## Service Information Bulletin

SUBJECT	DATE
SPN 5741 (ACM) (GHG17)	April 2017

### Additions, Revisions, or Updates

d150268

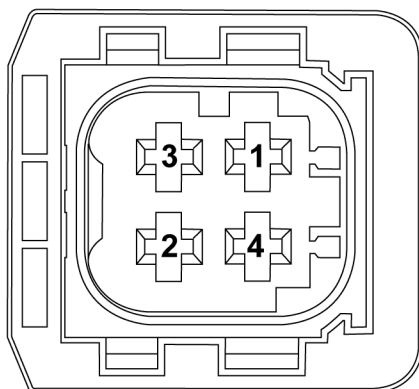
Publication Number / Title	Platform	Section Title	Change
DDC-SVC-MAN-0191	GHG17 Heavy Duty	SPN 5741/FMI 13 - GHG17	Voltage check moved before the resistance check.
DDC-SVC-MAN-0193	GHG17 Medium Duty	SPN 5741/FMI 13 - GHG17	MDEG and HDEP procedures are similar.

- a. Yes; repair as necessary. Verify repairs.
  - b. No; Go to step 6.
6. Turn the ignition ON (key ON, engine OFF).
7. Measure the voltage between pins 1 and 2 of the soot sensor harness connector, harness side. Is the voltage reading within .5 volts of battery voltage?

- a. Yes; Go to step 9.
  - b. No; Go to step 8.
8. Measure the voltage between pin 1 of the soot sensor connector harness side and ground. Is the voltage within .5 volts of battery voltage?

- a. Yes; repair the open circuit between pin 2 of the soot sensor connector and pin 96 of the ACM 120-pin connector.
  - b. No; repair the open circuit between pin 1 of the soot sensor connector and pin 66 of the ACM 120-pin connector.

9. Turn the ignition OFF.
10. Measure the resistance between pins 3 and 4 of the soot sensor connector harness side. Is the resistance between 55 and 65 ohms?
